January 10, 2025

Willis V. Carrier Recreation Center
Town of DeWitt
Project No. TOD PH3

Addendum No. 1

1
A12 **PAVILION CONCESSIONS - DEMOLITION PLAN**
Scale: 1/8" = 1'-0"

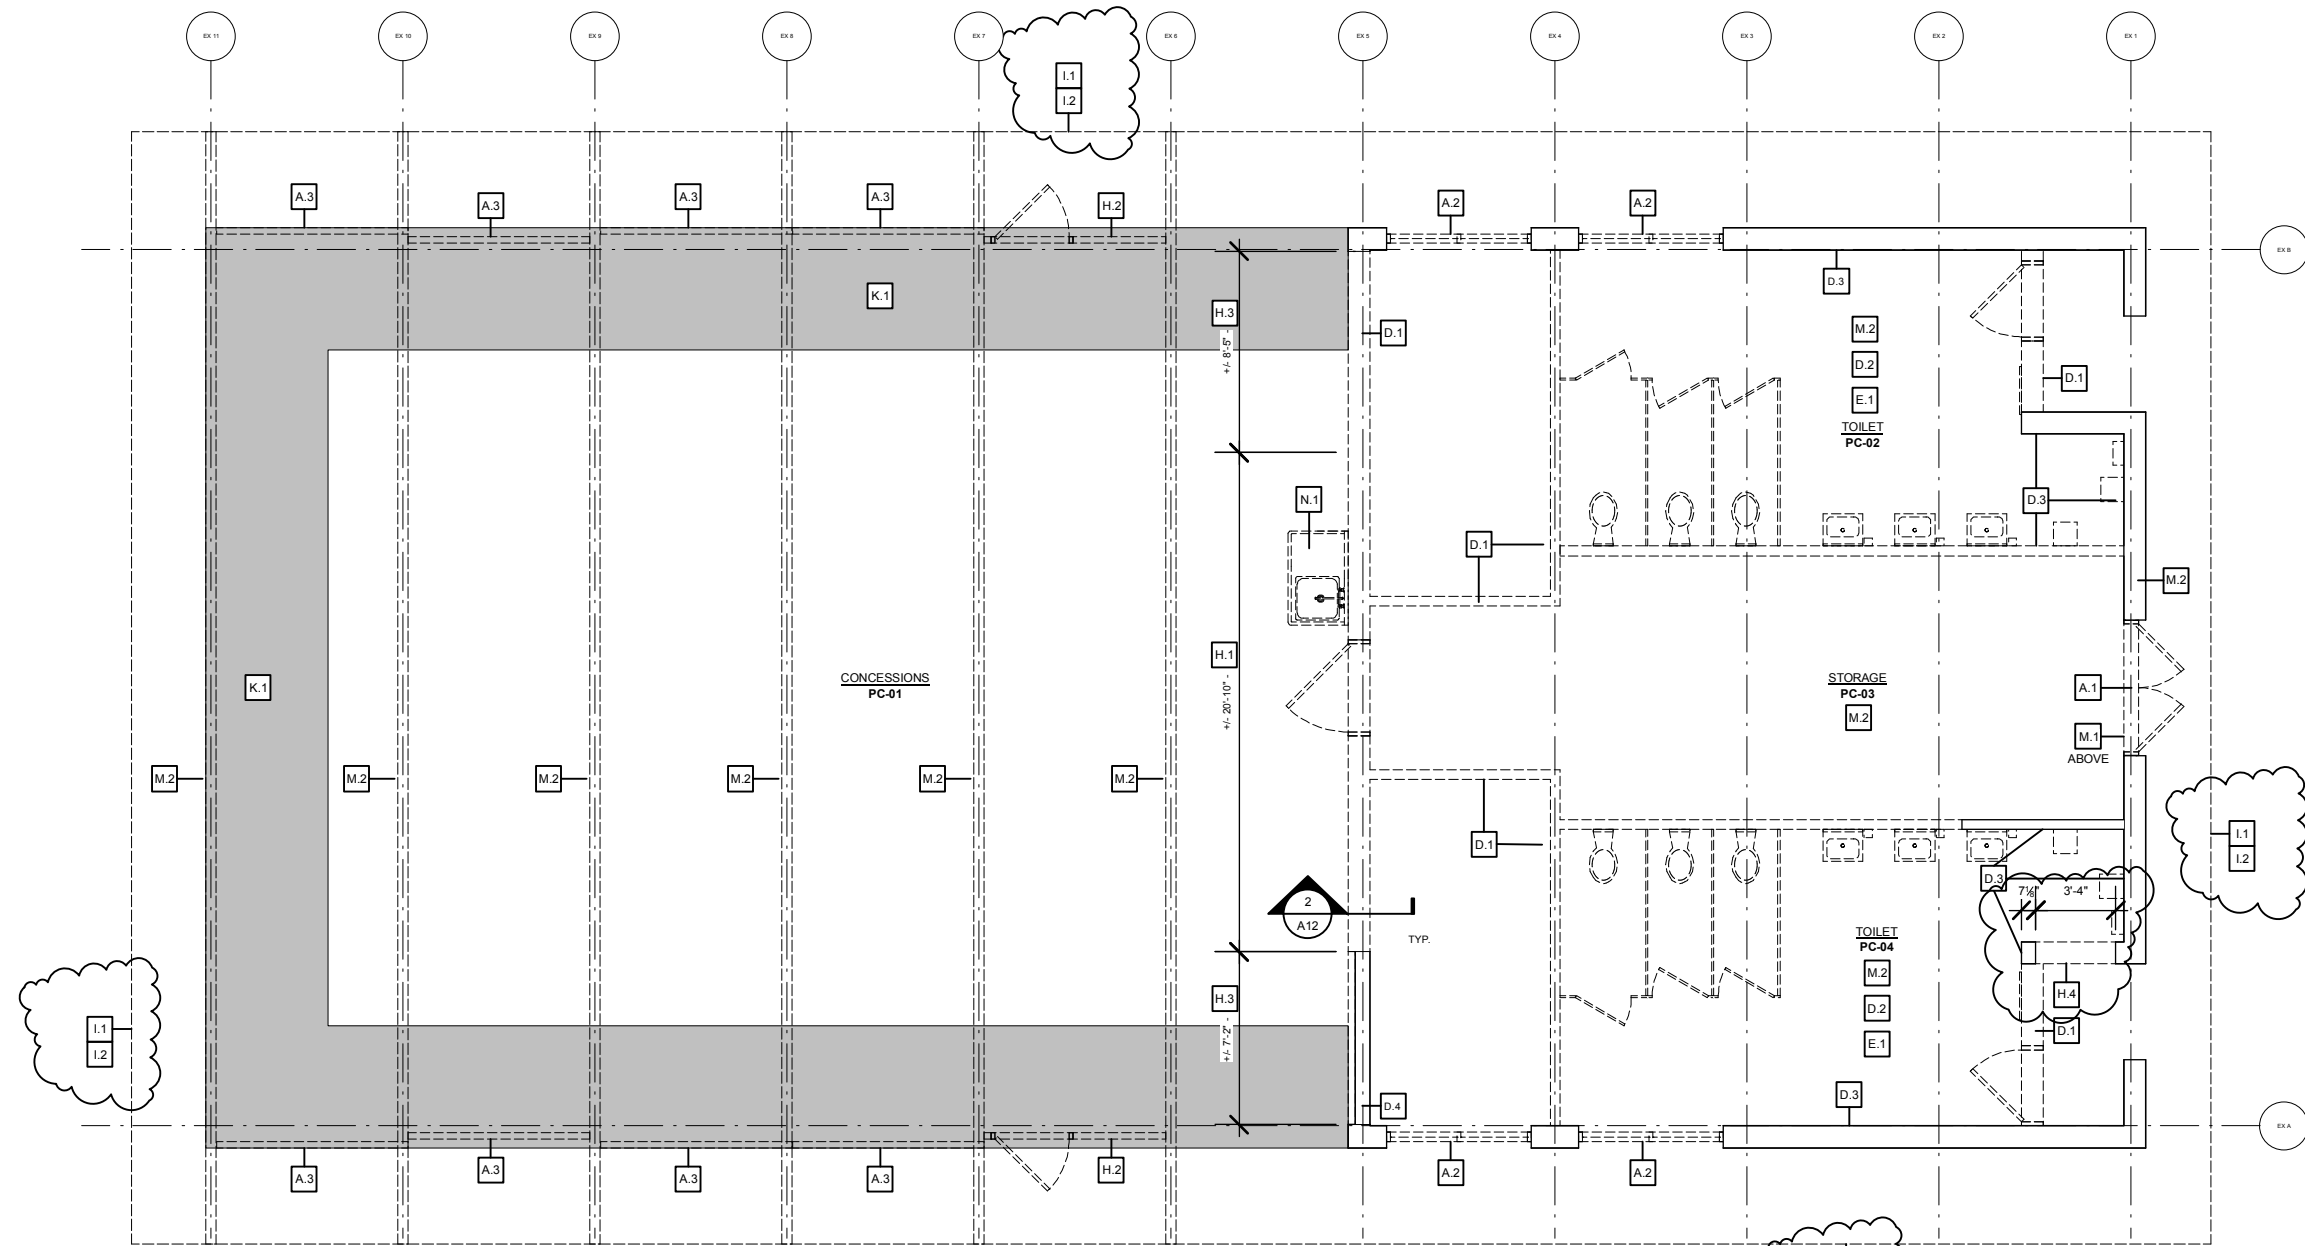
- o. On sheet A12:
 - 1.Detail 1/A12 - PAVILION CONCESSIONS – ROOF PLAN: **MODIFY** drawing as indicated on attached addendum drawing “**AD1-D5**”.
 - 2.DEMOLITION NOTES: **ADD** Demolition notes “**I.1 and I.2**” as shown on attached addendum drawing “**AD1-A5**”.

- I. ROOF DEMOLITION**
- i.1 REMOVE ASPHALT / FIBERGLASS SHINGLES AND COMPOSITE INSULATION COMPLETE DOWN TO WOOD PLANK DECKING. PREPARE WOOD PLANK DECK FOR INSTALLATION OF NEW INSULATION AND ROOF MATERIAL AS SCHEDULED.
 - i.2 REMOVE EXISTING ROOF EDGE METAL, FASCIA, AND SOFFIT COMPLETE. PREPARE AREAS TO RECEIVE NEW SCHEDULED FASCIA, EDGE METAL AND SOFFIT PANELS AS REQUIRED.
